# SSD 16\_7539: DARLINGTON TERRACES MIXED USE DEVELOPMENT

## THE UNIVERSITY OF SYDNEY, DARLINGTON CAMPUS

### RESPONSE TO SUBMISSIONS

9 JUNE 2020

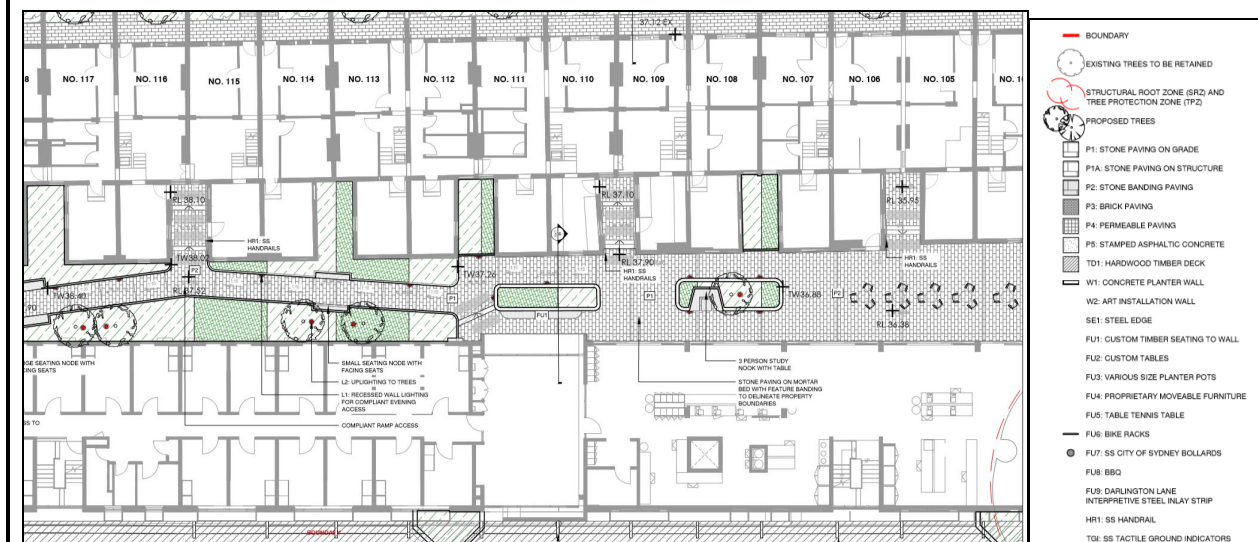
<p><b>Built Form and Urban Design</b></p> <p>2. The design of the new buildings must be revised to:</p> <p>a) ensure the articulation of the new buildings express the original subdivision to Darlington Lane</p>	<p><b>Agreed:</b> The façade treatment and articulation of the new buildings fronting Darlington Lane are amended by AJ+C Plans at <b>Appendices A &amp; M</b>. The memory of the original subdivision pattern is delineated on the Darlington Lane façades using steel markers which will be inset into the paving or road base. The markers match the location of the original lot boundary fences. The observer will become aware of the integral lot numbers and the regularity of the markers as viewed along the lane. The lot numbers will be easily read as large figures etched or laser cut into the markers, combined with further detail of the history of the lot. This detail will also be referenced on the ground plane within the paving as contrasting strips following the original lot boundaries.</p> <p>The amended design treatment references the rhythm and pattern of the rear of the terraces. Both composed of a main base, metal clad top and regular pop-outs. The pop-outs are the dominant feature on the south façade of the terraces providing a regular rhythm viewed from the laneway. The new pop-outs will not mimic the terraces but will provide a modern interpretation, having a similar proportion but composed of lightweight steel not masonry. The pop-outs, new and old, are regular but the pattern varies, they are interspersed by breaks and subtle changes along the way. The combination of the pop-outs as viewed obliquely along the lane combined with the breaks and the material changes within the façade ensure the building does not appear "as a single large form mass".</p>

Finally, the Landscape Plans (**Appendix K**) prepared by *Oculus* demonstrates a delineation of individual terrace subdivisions indicated by a lineal paving feature banding and reinforced using the plant palette (plant textures, colours, scale) – refer to the extract below.

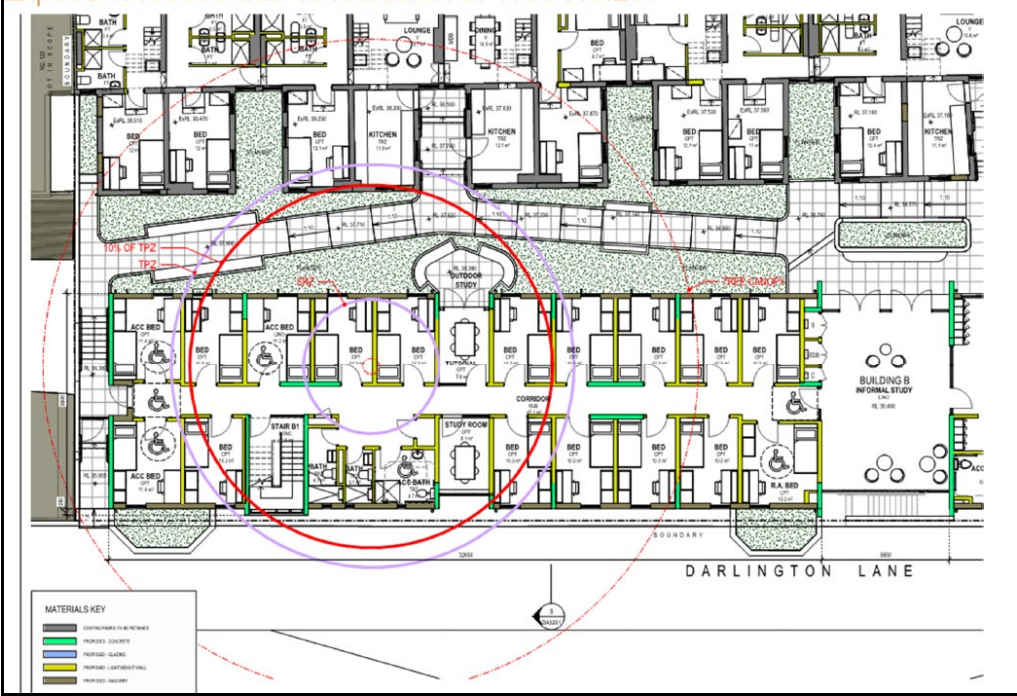
b) retain high value tree no. 25 at the rear of 116 Darlington Road unless further justification can be provided demonstrating that the building cannot be reconfigured so that the tree and its structural root zone is protected. The details currently provided regarding economic viability of the Darlington Terraces proposal is not sufficient to justify the removal of the tree.

The University maintains that the proposed removal of Tree 25 in this instance is concluded to be reasonable and justified for reasons including the overall increase and improvement of tree and landscape plantings for the site and campus. This RtS refers to the following attached documents in support of these findings:
